Historic Architectural Review Commission Staff Report for Item 15

Application Number: C2025-0035

Address: 612 Petronia Street (Rear)

Description of Work:

Existing Site Plan/Demo Plan.

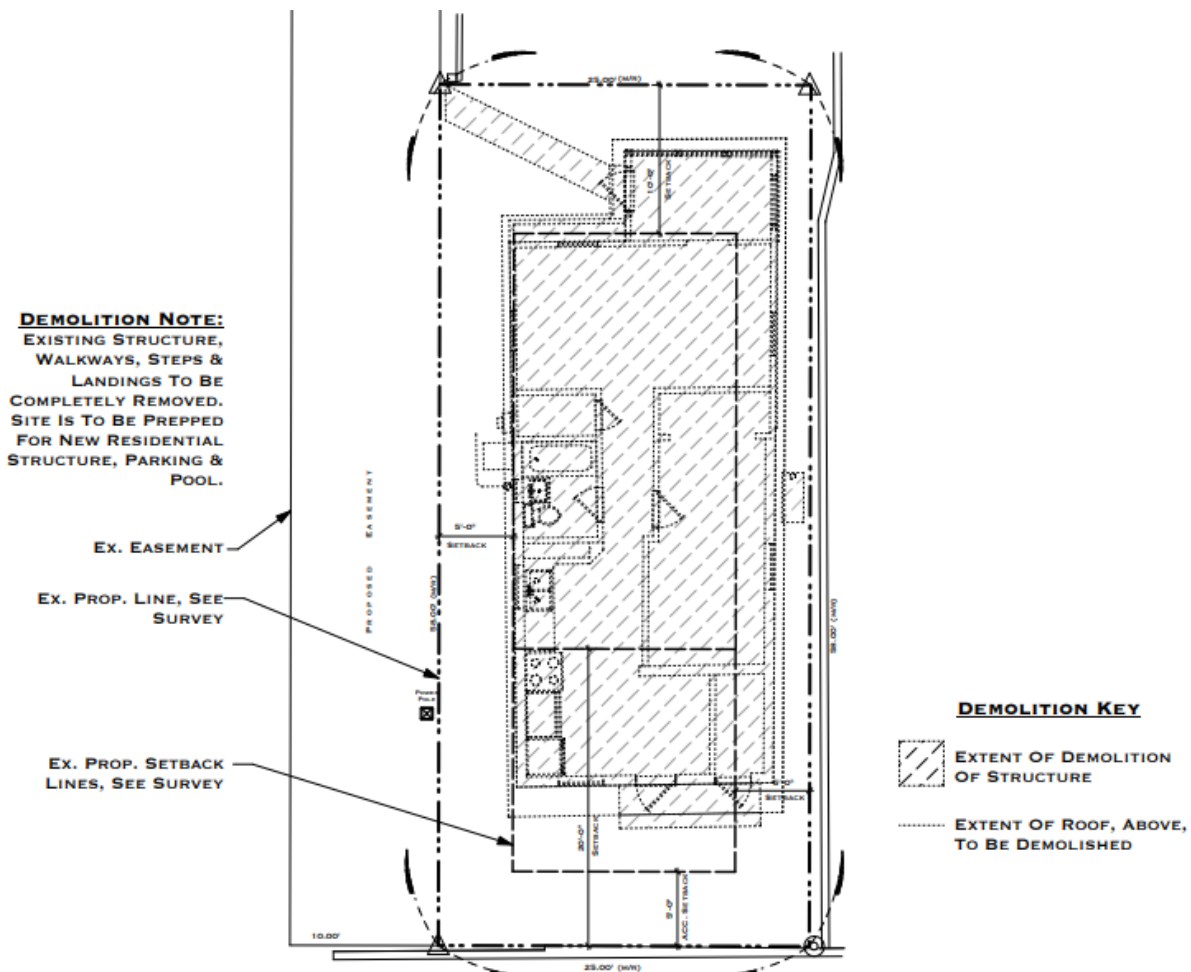
The Certificate of Appropriateness proposes the demolition of a one-story historic wood-frame and CMU structure, along with site features such as walkways and steps. This will clear the property for new construction. While the property is classified as non-contributing, it is considered historic. The exact construction date is unknown; however, the building appears on the 1962 Sanborn Map but is absent from the 1948 edition.

It is staff's opinion that the request for demolition may be considered, as the structures under review meet the criteria for demolition. The building is historic but it is not contributing and it does not show significant deterioration. If approved, this will be the only required reading. Staff will review submitted construction plans for demolition and design to ensure consistency with submitted drawings.
